Re: Long-Term Ground Water Quality Concerns based on
Review of the Application for Alternate Concentration Limits (ACLs)
TFN 3 3/122

MEMORANDUM

TO: Georgia A. Cash, District I Supervisor
FROM: Roberta N. Hoy, Geohydrologist *RNH*
DATE: May 1, 1999
RE: Review of Bear Creek ACL Application - TFN 3 3/122

Figure 5
SO4 Concentrations vs. Time
Bear Creek - TFN 3 3/122
February 1999

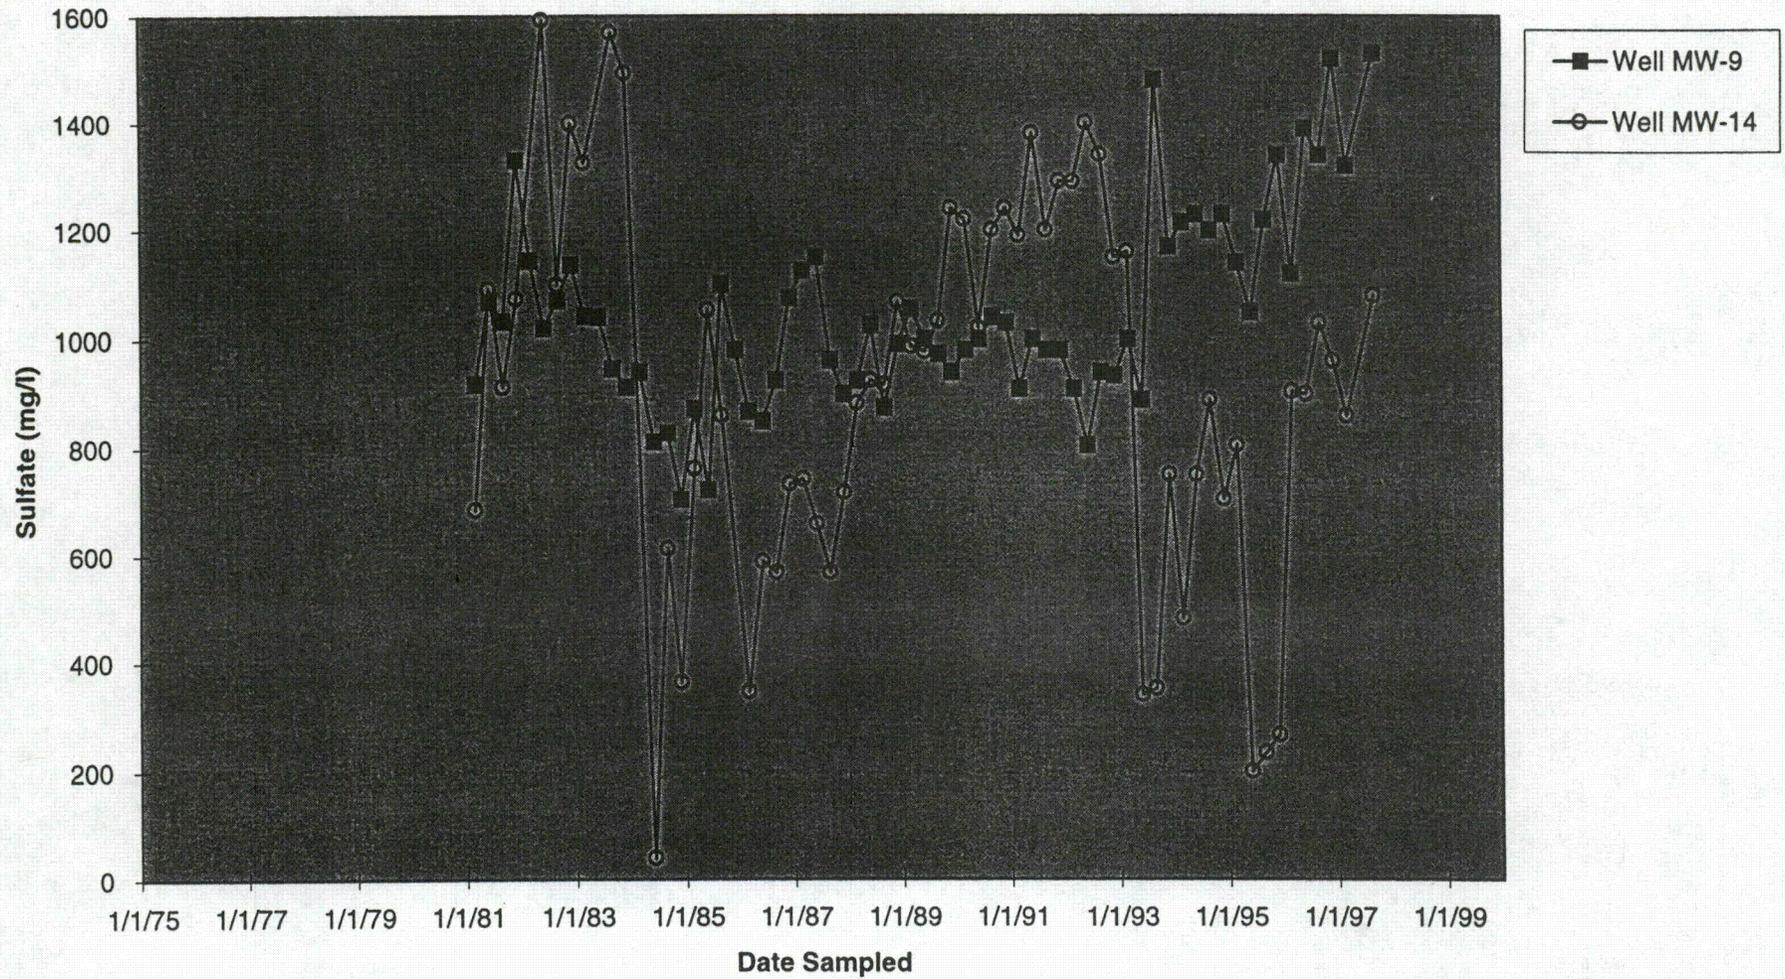
5.1 Lang Draw. Concentration changes in three wells, Wells MW-9, MW-14, and MW-23, raised concern about some of the simplifying assumptions on ground water movement in Lang Draw. For example, the sulfate concentrations in Well MW-9 were relatively steady over time, while the concentrations in Well MW-14 fluctuated significantly, even though both are alluvial wells and are within about 100 feet of one another. The difference was of particular concern because these two wells are near the POC well in Lang Draw (Figure 3). However, Well MW-14 is located in a portion of the draw in which snow drifts, while Well MW-9 is located on the bank of the draw. Therefore, the fluctuations are probably due in part to variations in recharge along the draw during snowmelt. As areal recharge was not taken into account in the predictions of contaminant movement along Lang Draw, the difference between the two wells was not considered critical to the predictions. (Section 6.0 provides additional discussion of the assumptions and conditions used in the predictions.)

Figure 6
SO4 Concentrations vs. Time
Bear Creek - TFN 3 3/122
February 1999

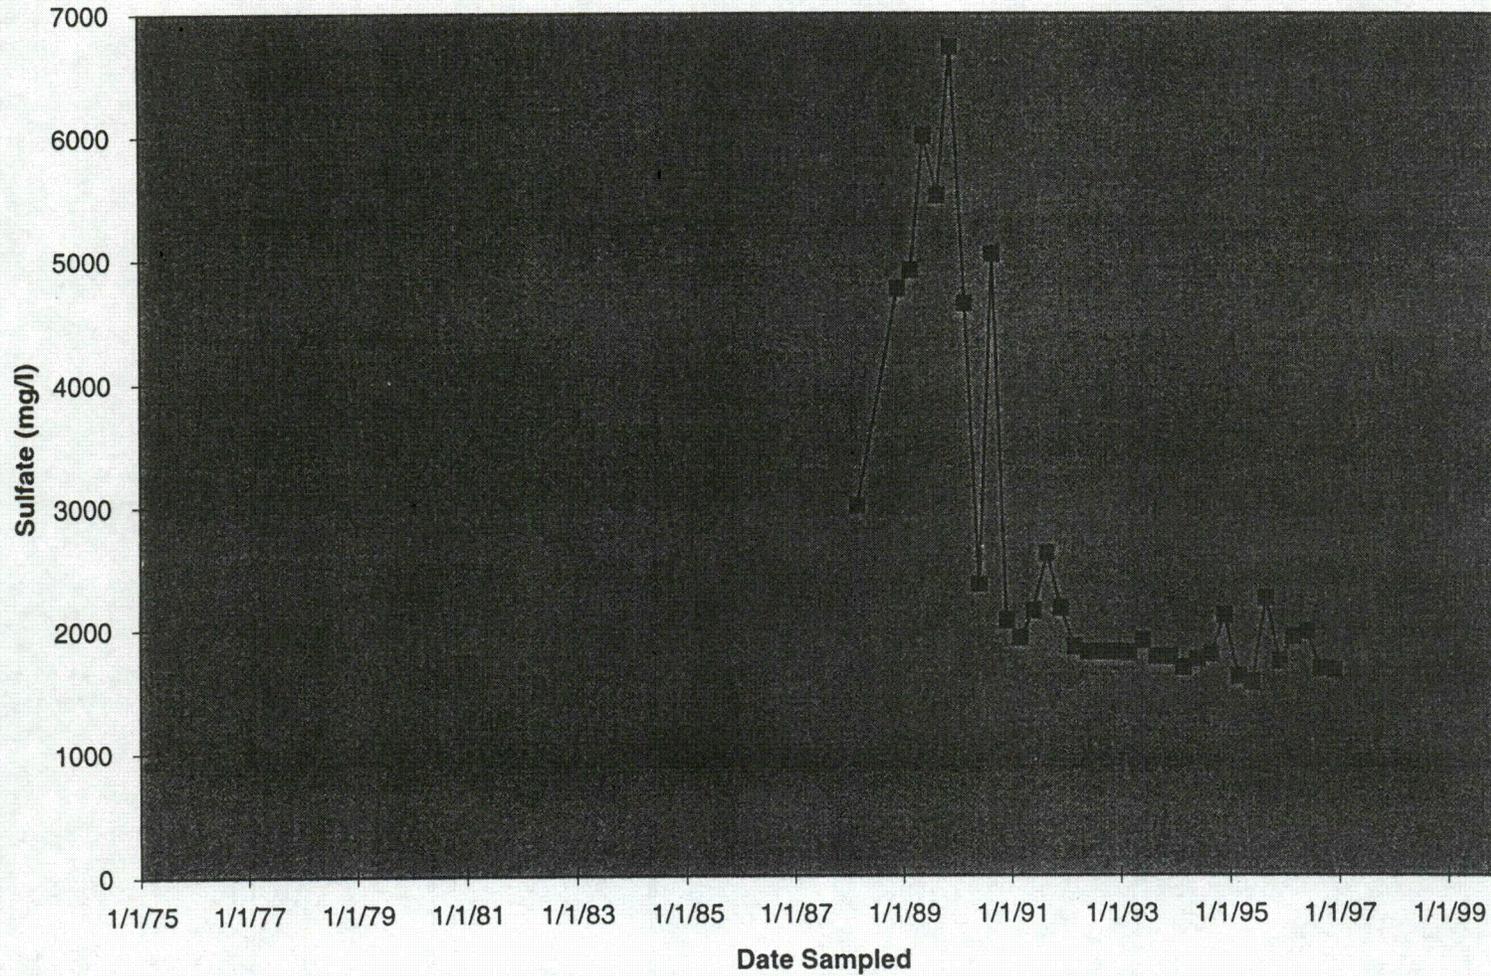
The rapid decline in the sulfate concentration in Well MW-23 was also of concern in case it represented movement of a 'slug' of higher contaminant concentrations past the well (Figure 6). However, Bear Creek indicated that the change in the sulfate concentrations was due to well redevelopment. Prior to 1991, the well was hand-bailed and the samples were described as black, brackish water. After well redevelopment and changing the sampling technique, more consistent data was obtained which was comparable to other wells in the vicinity.

Figure 7
SO4 Concentrations vs. Time
Bear Creek - TFN 3 3/122
February 1999

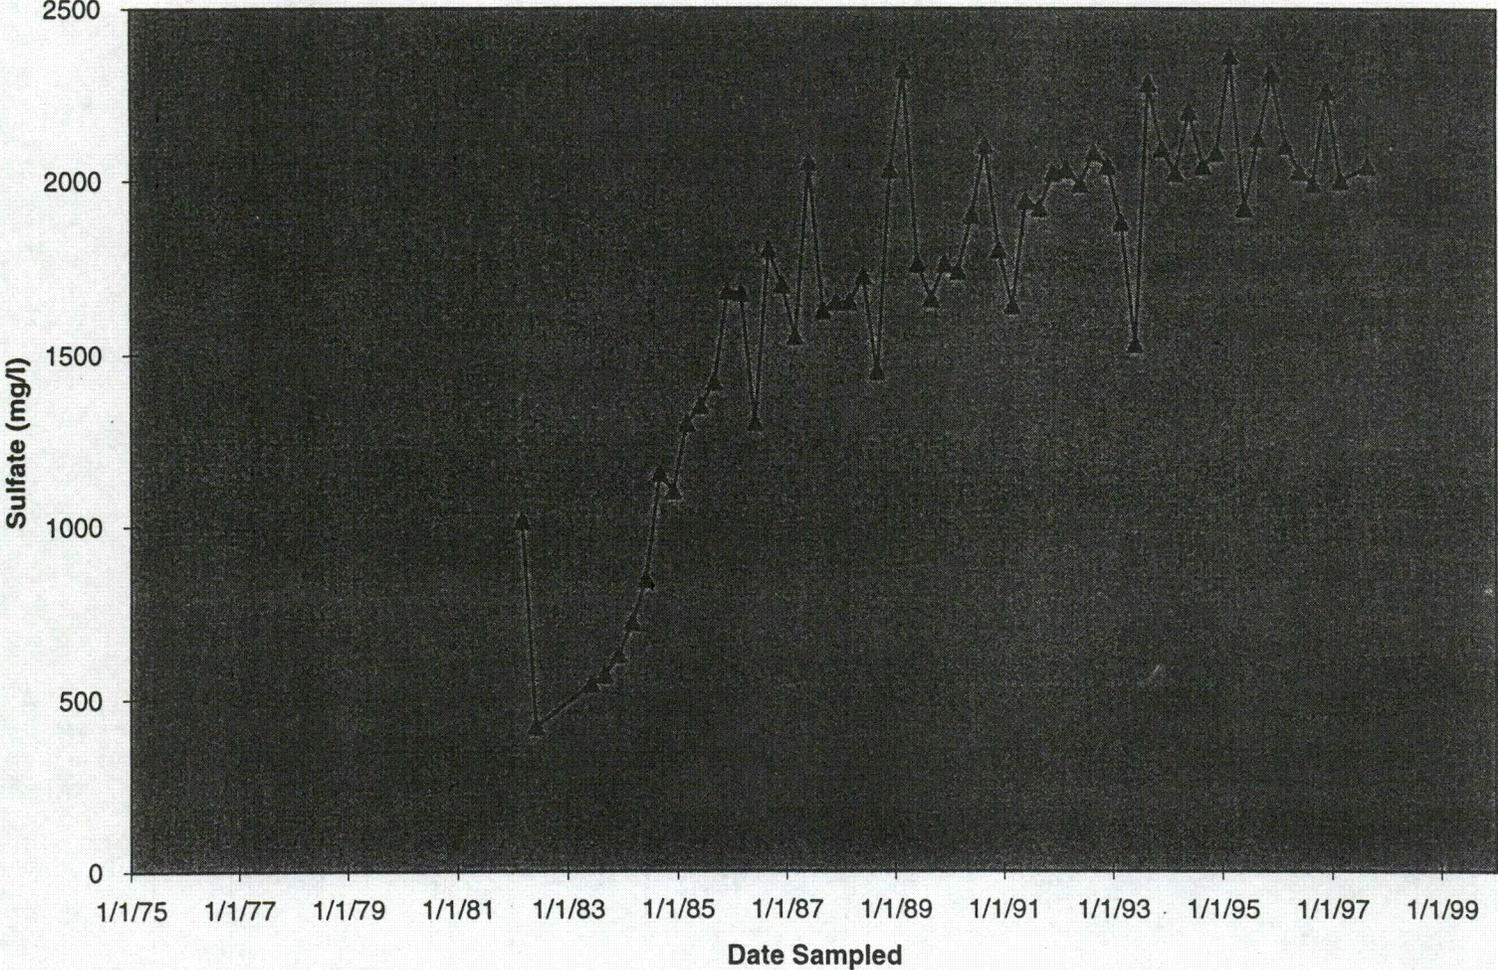
5.2 Northern Flow Path. Concentration increases of parameters, such as sulfate, in Well MW-43 were more rapid than would be expected from the ACL evaluation, potentially indicating the ground water flow rates used in the predictions were too low (Figure 7). However, the initial concentration changes in this well are attributable to a spill at the mill site; therefore, they cannot be used as a 'tracer' of contaminant movement from the tailings.

Figure 9
SO4 Concentrations vs. Time
Bear Creek - TFN 3 3/122
February 1999

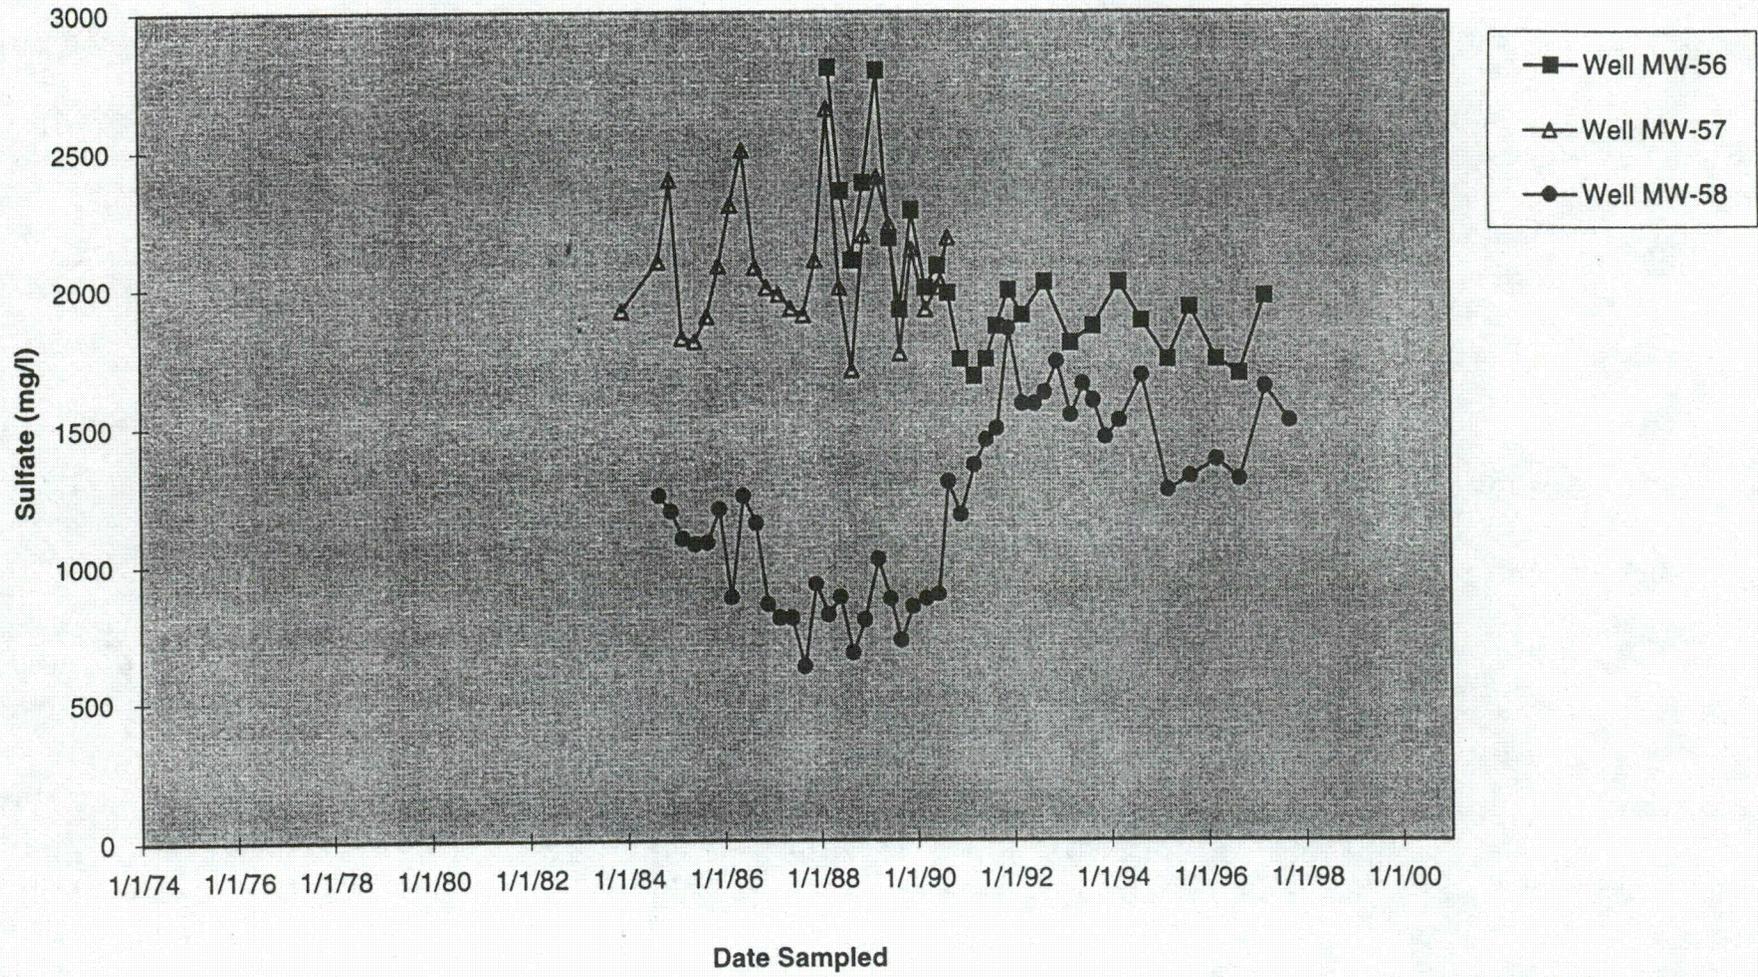
5.3 Lateral Migration. The limited lateral migration is best illustrated by wells along the western edge of the tailings, in particular Wells MW-56, MW-57, MW-58, MW-60, MW-61, and MW-64 (Figure 3). Wells MW-56 and MW-57 are both K-Sand wells completed within the tailings impoundment area. Well MW-58 is a K-Sand well just west of Wells MW-56 and MW-57, but outside of the tailings impoundment area. Water levels in both Wells MW-56 and MW-57 declined rapidly during the tailings dewatering, but the water level in Well MW-58 has remained relatively constant (Figure 8). Sulfate concentrations in all three wells are relatively low, on the order 1,000 to 3,000 milligrams per liter (mg/l), in comparison with the sulfate concentrations in the tailings solution on the order of 18,000 to 20,000 mg/l (Figure 9).

Figure 12
SO4 & Cl Concentrations vs. Time
Bear Creek - TFN 3 3/122
February 1999

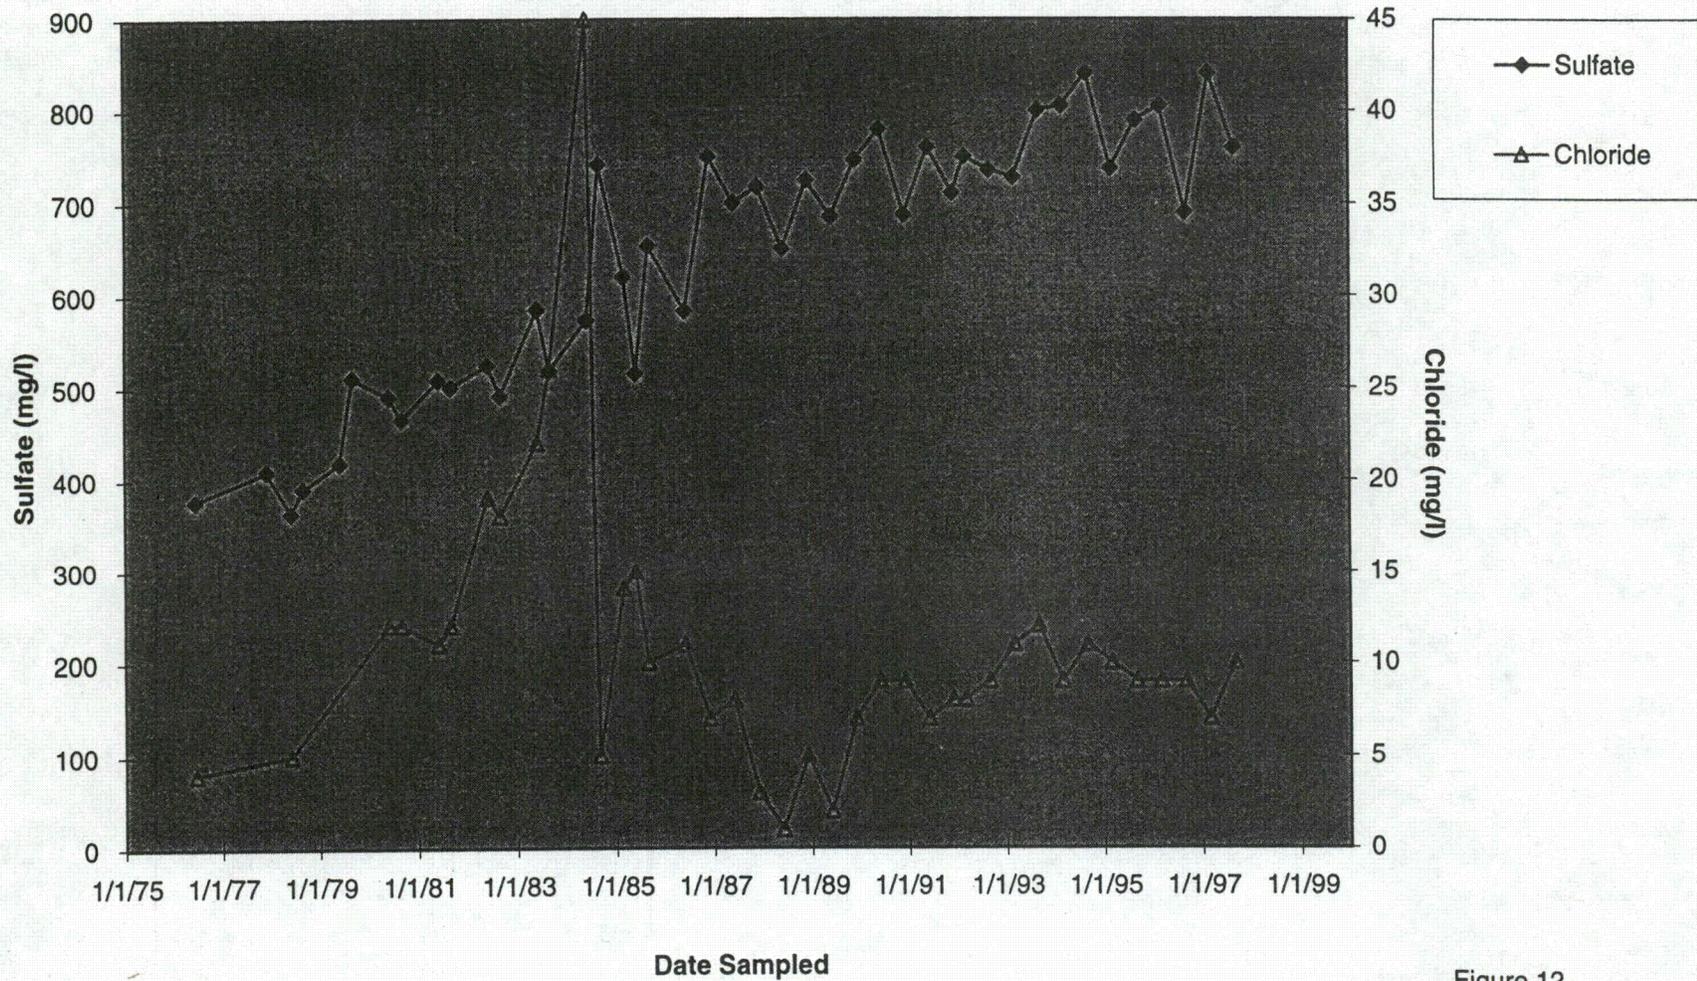
5.4 *Ore Sand*. Although the aquitard between the Ore Sand and the N-Sand was considered to be an effective aquitard, the increase in sulfate concentrations in Well MW-2 was of concern (Figure 12). The increase could be due to the influence of mining of the Ore Sand; however, it could have also been due to leakage through the aquitard in the vicinity of the well or due to poor well completion. However, there was no corresponding increase in chloride concentrations in the well. Therefore, the increase is considered to be due to the influence of mining, not due to the influence of tailings leakage.
